## S U B M I S S I O N: G O D D E N a written submission by way of objection to DA 2021/0419

266 Whale Beach Road, Whale Beach DA 2021 0419

WRITTEN SUBMISSION: LETTER OF OBJECTION

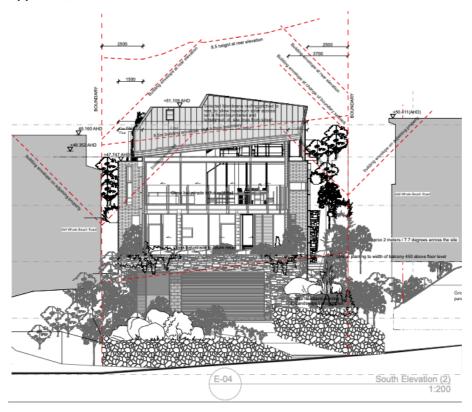
We ask DDP to impose **Deferred Commencement Conditions**:

- 1. The proposed dwelling is to be repositioned to the east, by increasing the western side setback to Grid A to have a 2.5m side setback to the western boundary, and the eastern side setback to Grid E to have a 1.0m side setback. Adjust external works to suit. Reason: to better accord to D12.8 Building Envelope
- 2. The proposed dwelling is to be lowered by 1.0m. Adjust external works to suit. Reason: to better accord to D12.8 Building Envelope
- 3. Windows facing west to have obscured glass. Reason: to provide better privacy outcomes to neighbours to the west
- 4. 1.65m high privacy screens to the western side of the proposed elevated Courtyard at Second Floor. Reason: to provide better privacy outcomes to neighbours to the west
- 5. Stormwater trench to be positioned along western boundary to collect all surface and subsurface stormwater. Reason. Flooding
